#### **Addendum 104 – Regulation No. 105**

#### **Revision 2 – Amendment 3**

06 series of amendments – Date of entry into force: 22 June 2017

#### **Uniform provisions concerning the approval of vehicles intended for the carriage of dangerous goods with regard to their specific constructional features**

5.1.1.2.2. Additional Protection

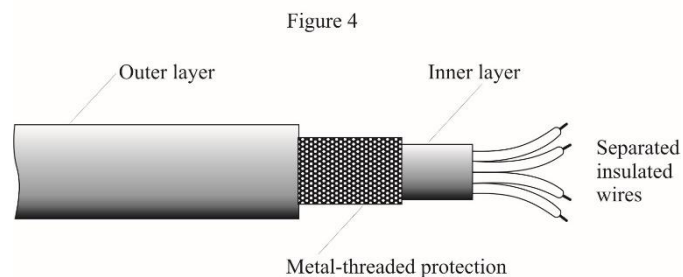
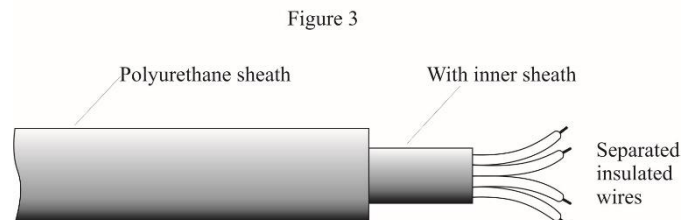
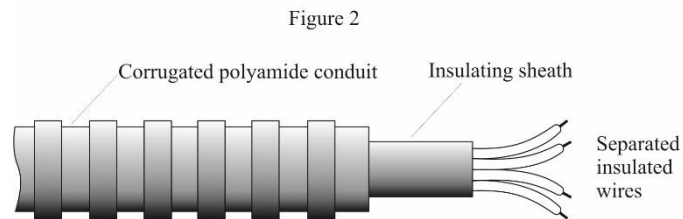
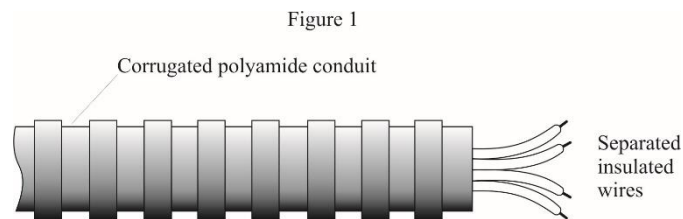
Cables located to the rear of the driver's cab and on trailers shall be additionally protected to minimize any unintended ignition or short-circuit in the event of an impact or deformation.

The additional protection shall be suitable for the conditions during normal use of the vehicle.

The additional protection is complied with if multicore cables in conformity with ISO 14572:2011 are used or one of the examples in Figures 1 to 4 below or another configuration that offers equally effective protection is used.

Model A

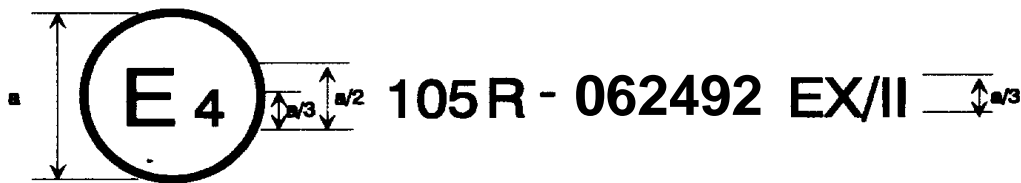
The above approval mark affixed to a vehicle shows that the vehicle type concerned, intended for the transport of dangerous goods, has been approved in the Netherlands (E 4), pursuant to Regulation No. 105, under the approval number 062492 and designated EX/II (according to paragraph 9.1.1.2. of Annex B to the ADR). The first two digits of the approval number indicate that the approval was granted in accordance with the requirements of Regulation No. 105 as amended by the 06 series of amendments.

Model B

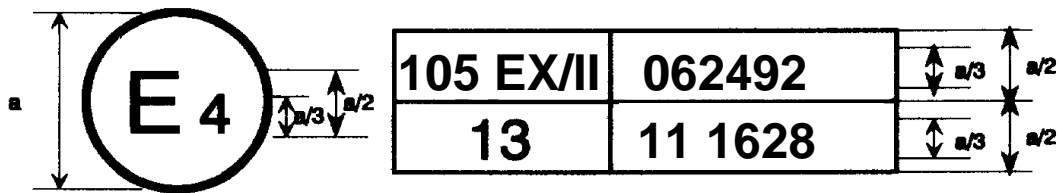
The above approval mark affixed to a vehicle shows that the vehicle type concerned has been approved in the Netherlands (E 4) pursuant to Regulations Nos. 105 and 13<sup>1</sup>. The first two digits of the approval numbers indicate that, at the dates when respective approvals were granted, Regulation No. 105, as amended by the 06 series of amendments, while Regulation No. 13 already included the 11 series of amendments.
